SERVICE BULLETIN

N° 139-695

ATA 56 - INSTALLATION OF ACRYLIC WINDSHIELDS

This Service Bulletin is issued in order to provide the necessary instructions on how to perform the installation of the kit acrylic windshields P/N 3G5610F00211.

Figure 9

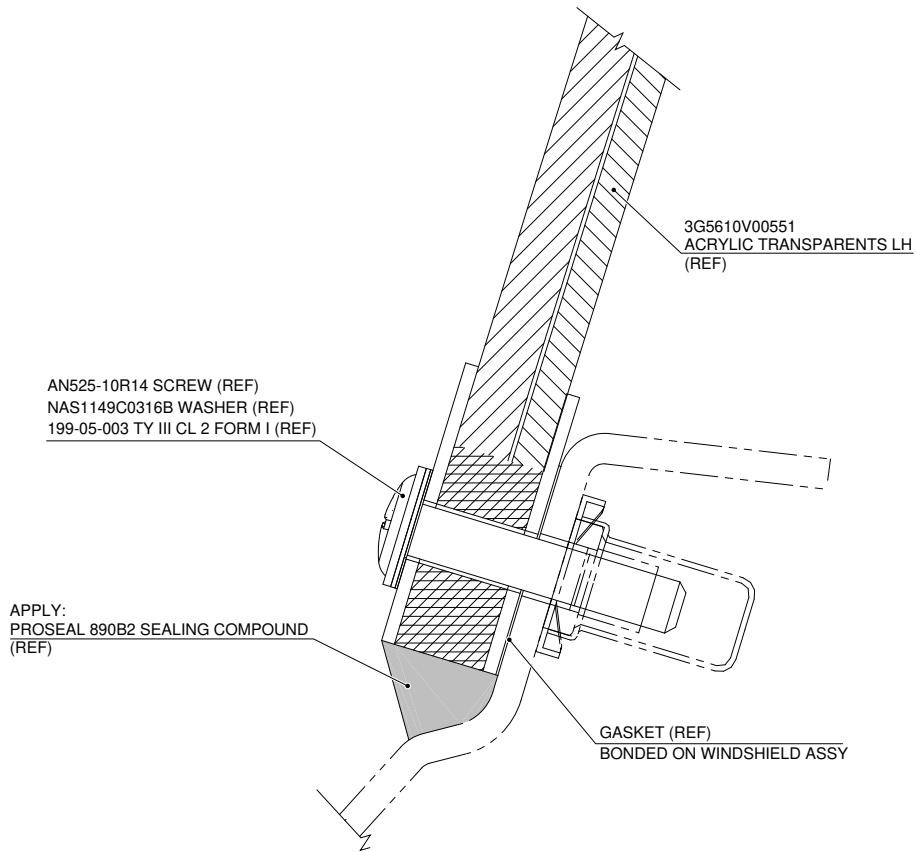
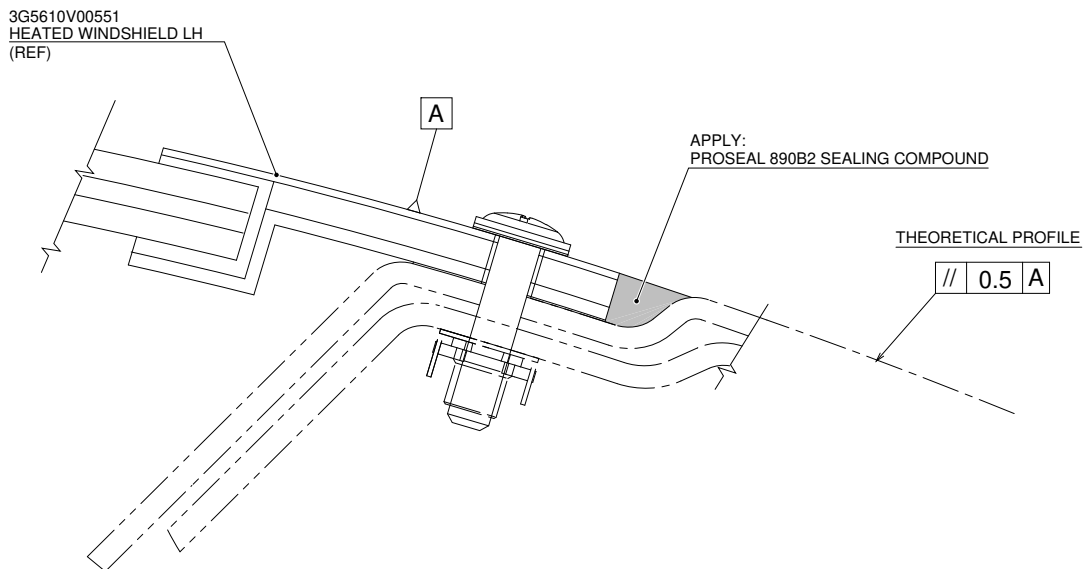
While performing step 14 and step 15 if necessary, it is permitted to increase the diameter of the transparent attach holes to a maximum of 5.90÷6.01 mm.

14. In accordance with AMP DM 39-C-56-13-01-00A-720A-K and with reference to Figures 8 thru 10, install the acrylic transparent LH P/N 3G5610V00551
15. In accordance with AMP DM 39-C-56-13-02-00A-720A-K and with reference to Figures 8 thru 10, install acrylic transparent RH P/N 3G5610V00651.
16. In accordance with AMP DM 39-A-06-41-00-00A-010A-A, re-install all external panels, internal panels and internal liners previously removed as required.
17. In accordance with weight and balance changes, update the Chart A (see Rotorcraft Flight Manual, Part II, section 6).
18. Return the helicopter to flight configuration and record for compliance with this Service Bulletin on the helicopter logbook.
19. Send the attached compliance form to the following mail box:
